FARRAGUT MUNICIPAL PLANNING COMMISSION AGENDA

**August 19, 2021
Farragut Town Hall
Board Room**

**MINUTES
FARRAGUT MUNICIPAL PLANNING COMMISSION**

July 15, 2021

SUBJECT: Discussion and public hearing on amendments to the approved site plan for the Kingston Pike Village – Phase 2 (Grocery Store and Retails Shops), 115 S. Watt Road, Zoned PCD, 8 Acres (SITE Incorporated, Applicant)

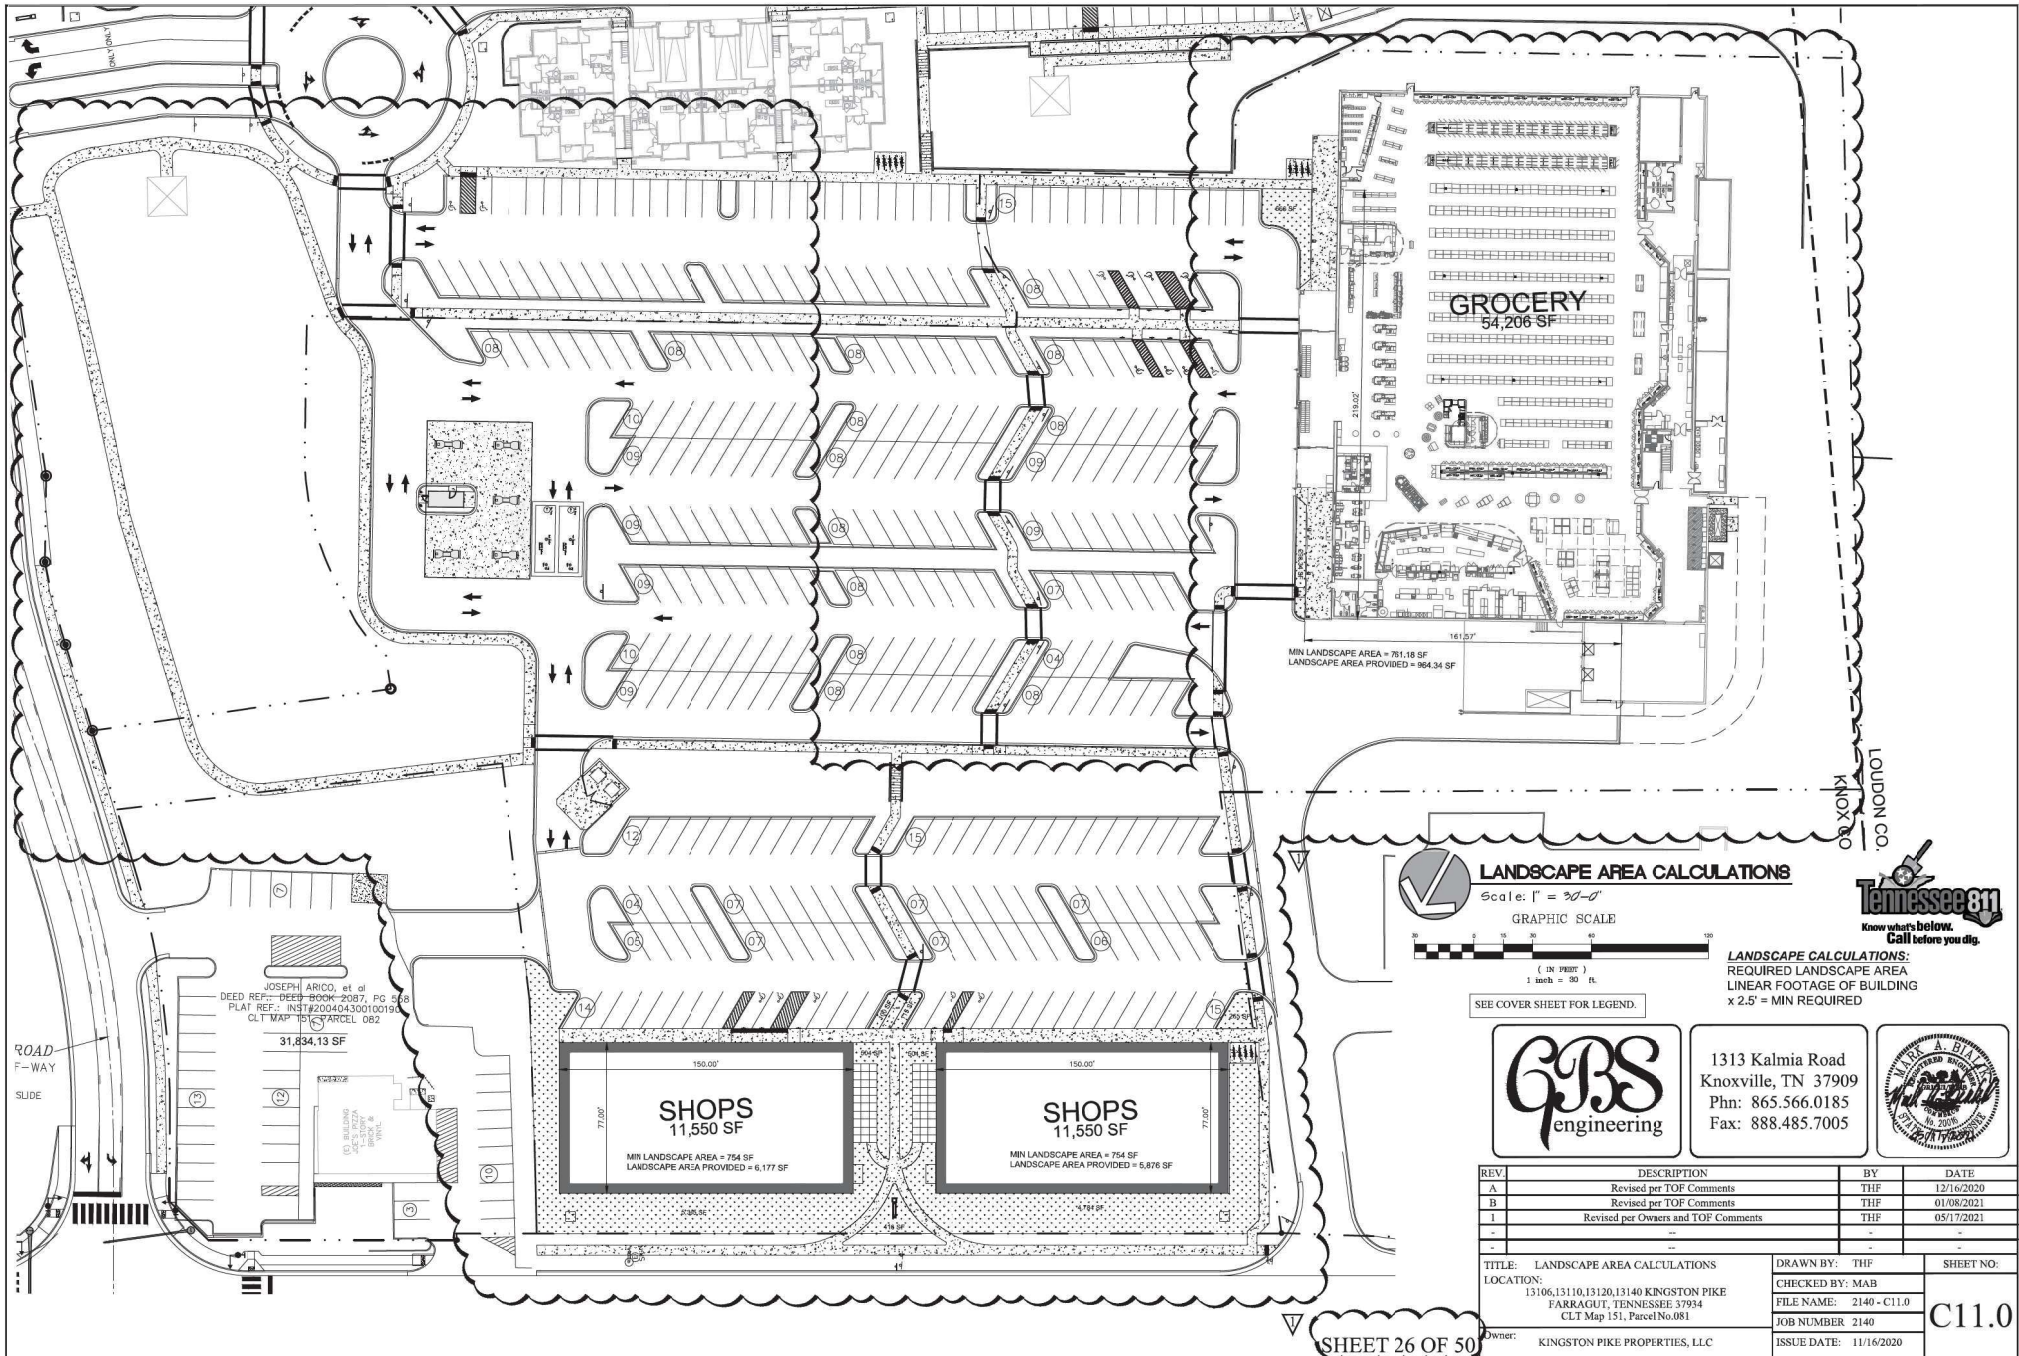
DISCUSSION: After reviewing the modifications at the June workshop session, Commissioners were supportive and in favor of moving forward with finalizing the amended site plan set. Unfortunately, since the June workshop discussion, the project engineer passed away and there were no other engineers in his company to take over. SITE Incorporated was hired by the developer to finish the site plan for this project.

Select sheets from the latest site plan set are included in the packet. One of the discussion items in June was the existing access off Kingston Pike for the Little Joe's Pizza. The parties involved have agreed to remove the existing access. From both the Town staff and likely TDOT's position, this is a good result. The existing access is very close to S. Watt Road and does not comply with Town or TDOT requirements. Another discussion item involved updating the landscape plan to reflect the changes resulting from these latest site plan modifications. A revised landscape plan will be taken to the VRRB this month.

SUBJECT: Discussion and public hearing on a line-of-sight evaluation associated with the screening requirements for outdoor storage and sales related to a site plan for Moses Watersports, Parcel 176.02, Tax Map 130, 11470 Outlet Drive, Zoned OD-RE/E, 6.8 Acres (Urban Engineering, Inc., Applicant)

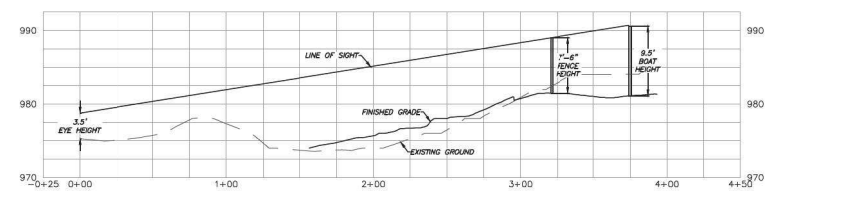
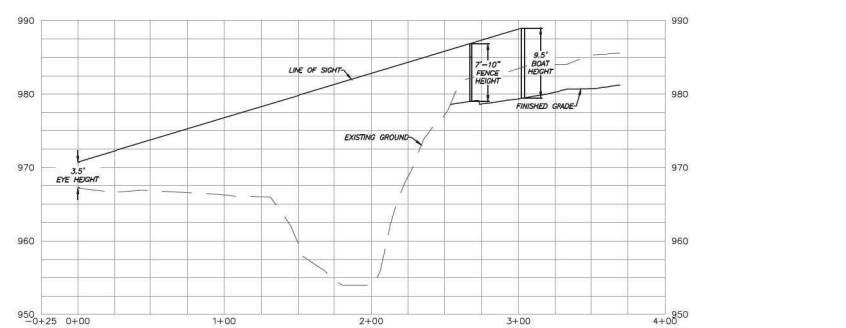
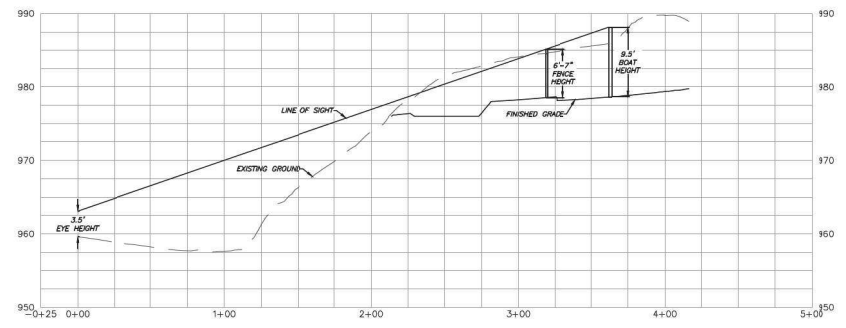
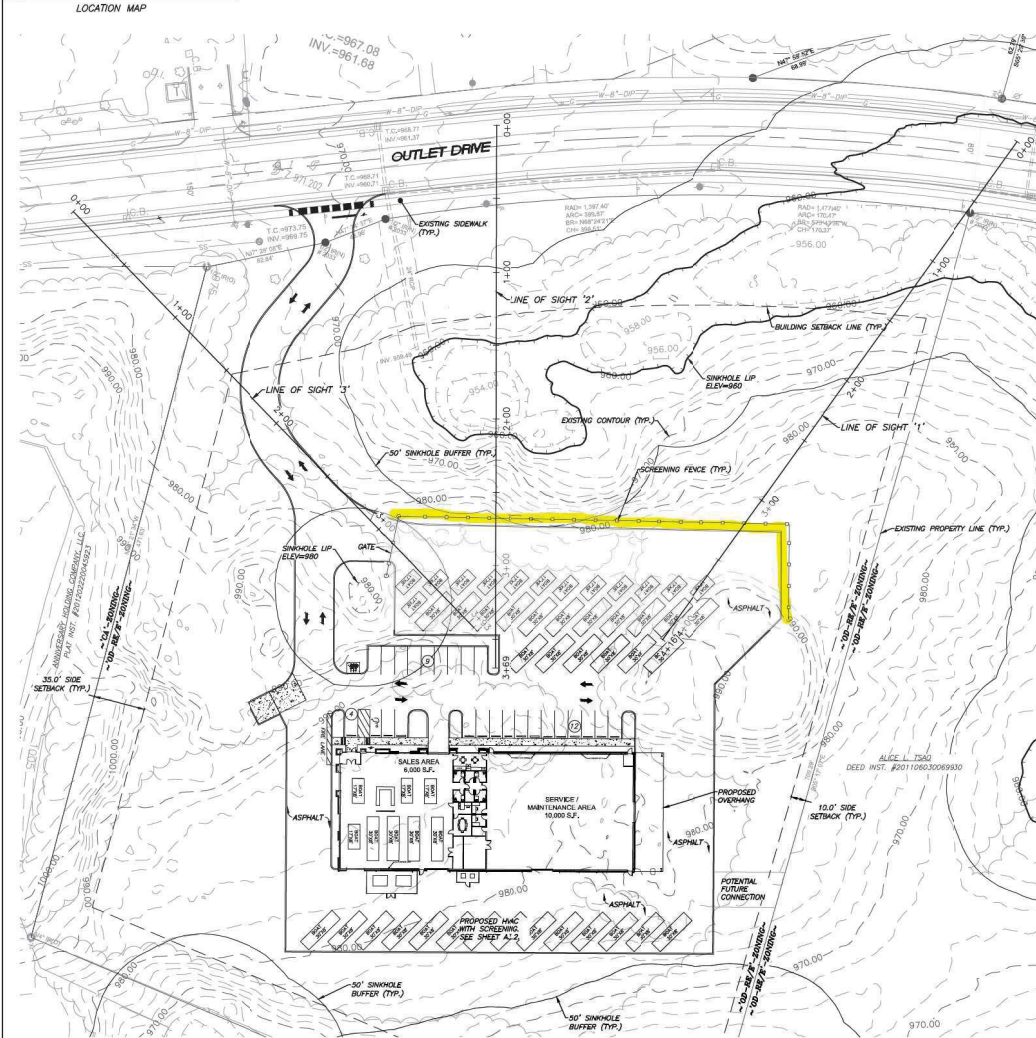
INTRODUCTION AND BACKGROUND: At the Planning Commission meeting last month one of the items discussed in relation to the site plan for the Moses Watersports project along Outlet Drive was the screening required to conceal the outdoor storage and sales from the right of way. As presented at that time, the site plan included a four-foot fence along mostly the northern limits of the storage area.

A comment from both staff and some commissioners was whether the fence would be high enough to meet the screening requirement, given that boats would be sitting on trailers. The project engineer stated that they would prepare a line-of-sight diagram to assess the height needed based on elevation change from Outlet Drive to the proposed outdoor storage area. This line-of-sight diagram would then be presented to the Planning Commission for their consideration.

RECOMMENDATION: Included in the packet is the proposed location for the screening fence (in yellow) and a detail of the proposed eight-foot-tall screen fence. As proposed, the fence will be constructed of wood colored to match the dark bronze storefront. Wood posts will be provided every eight feet. Main support posts will be provided every 50 feet and will be 16 inches in width and covered in a brick veneer to match brick used on the building.

SUBJECT: Discussion on a concept for outdoor storage and display of farm implements and lawn care equipment on the property at 13127 Kingston Pike in association with the Ag-Pro (formerly Farragut Lawn and Tractor) at 13131 Kingston Pike, Zoned C-1 (Stewart Ritchie, Applicant)

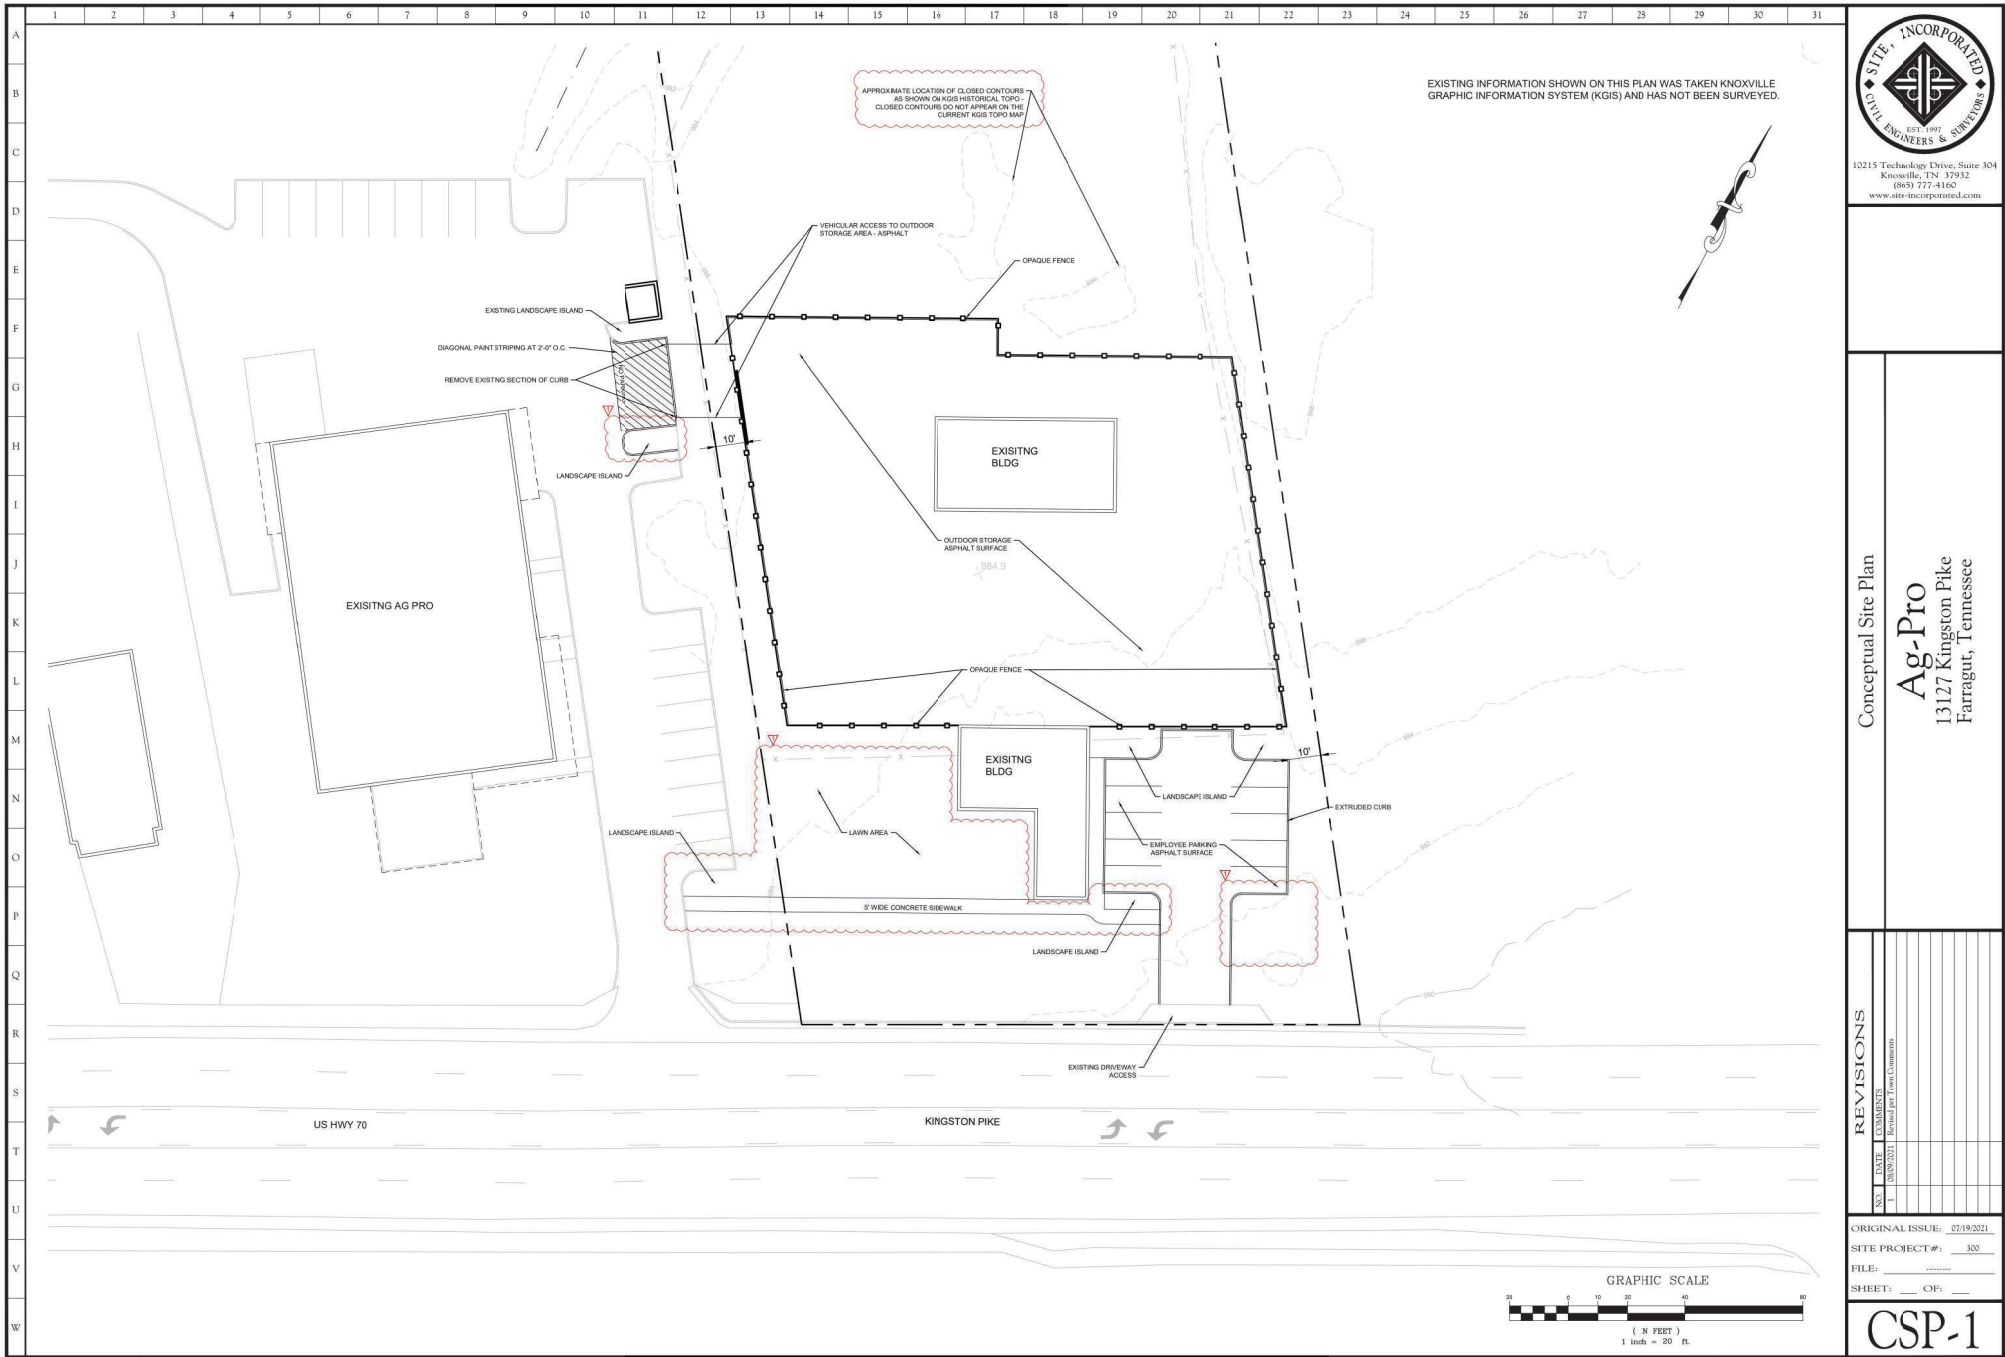
DISCUSSION: As shown on the concept plan included in the packet, Ag-Pro would use the adjacent property for a storage area that would be screened with fencing and construct a small parking lot for employees. The two existing buildings on the property would remain unused and would not be part of the business. The original concept site plan that was discussed at the staff/developer meeting on August 3 also included an area where they would like to display merchandise.

Recently, some amendments were made to the storage and display provisions associated with the farm implement and lawn care equipment use provided for in the General Commercial (C-1) portion of the Zoning Ordinance. Though the amendments expanded the area that could be used for display, the language ultimately restricted this area to being at least 20 feet from the front property line and no more than 50 feet from the front plane of the building, excluding any protrusions beyond the primary front plane. In this context, the “building” would be the building associated with the business. Consequently, without additional amendments to this section of the Zoning Ordinance, display of merchandise on the adjacent property would not be permitted.

The area proposed for storage would appear to be permitted if provided on an improved surface compliant with the Town’s provisions for parking and loading and designed for such storage. Staff would need to review the lease agreement in relation to additional use of the property, including the existing buildings. This would be a review consideration for any subsequent site plan involving the use of the adjacent property for the Ag-Pro business. Staff and the Town Attorney have met with the applicant concerning this review necessity. Depending on feedback provided by the Planning Commission, a more detailed site plan submittal will be provided for a subsequent meeting.
